Department of Energy
Idaho Operations Office
1955 Fremont Avenue
Idaho Falls, ID 83415

SUBJECT: Response to Request for Additional Information Regarding the Three Mile Island-2 (TMI-2) Independent Spent Fuel Storage Installation (ISFSI) (Docket 72-20) (TAC No. L23812) (EM-FMDP-05-031)

**Response to the May 18, 2005 Nuclear Regulatory Commission
Request for Additional Information Regarding the
DOE Request for License Amendment for the Three Mile Island Unit 2
Independent Spent Fuel Storage Installation
TAC No. L23812, Docket 72-20**

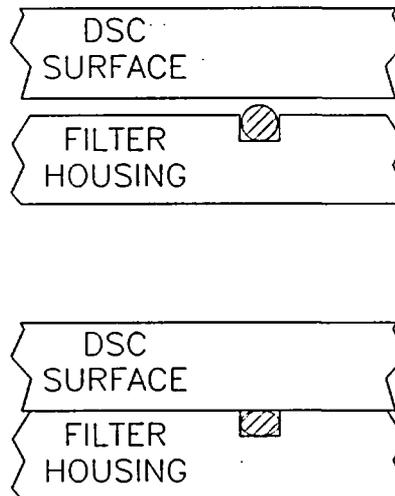
Request 4-2: Justify that the new polymeric o-rings can withstand the same torque as the metal seals without damaging the polymeric o-ring. The license amendment request states that the same amount of torque (82 ± 5 ft-lb) used for the old metal seals will be applied to the new replacement of elastomeric o-rings.

Response 4-2: The sealing capability provided by the elastomeric o-ring results from compressing the o-ring seated in the filter housing o-ring groove against the mating DSC surface. Compression, as defined by the manufacturer, is the diameter reduction from the no load condition to the compressed condition. The amount of compression that would be applied to the elastomeric seals under the above joint configuration is within the range recommended by the o-ring manufacturer.

The bolt torque specified in the TMI-2 ISFSI SAR generates a metal-to-metal compressive preload between the filter housing and the DSC surface, creating a closed static (non-moving/non-flexible) joint. In other words, the metal face of the DSC surface is in contact with and compressed against the metal face of the filter housing under all service conditions. The following sketch, not drawn to scale, is provided to show the proposed placement and seating of the elastomeric o-rings in the filter housing groove and the mating DSC surface.

The torque applied to each bolt (82 ± 5 ft-lbs each) equates to a minimum bolt preload of 4,863 lbs. each for a total compressive load (with eight bolts per filter housing) of 38,904 lbs. Some of the load is needed to compress the seals located in grooves in the filter housing. Once a metal-to-metal joint is achieved, the seals (either metal or elastomeric) are appropriately compressed and no further seal compression occurs. The remaining compressive load is absorbed by the metal-to-metal interface between the filter housing and the DSC surface and is designed to ensure metal-to-metal contact during the normal and accident conditions addressed in the SAR.

The bolt torque specified in the SAR provides a compressive load of 21,865 lbs to seat the metal seals (300 lbs/in for two seals of 10.8" and 12.4" diameter) before metal-to-metal contact is achieved between the filter housing surface and the DSC surface. The remaining compressive load of $(38,904 - 21,865 =)$ 17,039 lbs preloads the interface of the filter housing to the mating DSC surface. When elastomeric seals are used, the compressive load applied to the seals diminishes significantly due to the more elastic properties of the elastomeric seal material. The force required to seat the elastomeric o-rings is calculated from the manufacturer's design charts at (35 lbs/in for two seals of 10.8" and 12.4" diameter $=$) 2,551 lbs. This application results in $(38,904 - 2,551 =)$ 36,353 lbs as the remaining compressive preload between the filter housing and the mating DSC surface. Therefore, use of the elastomeric o-ring increases the metal-to-metal joint preload by $(36,353 - 17,039 =)$ 19,314 lbs over the use of the metallic seals. Though this excess joint preload is unnecessary from a joint design standpoint, it is preferred to keep all the bolt torques the same for consistency of operations rather than to reduce the bolt tightening torques for those joints which would utilize the elastomeric seals.
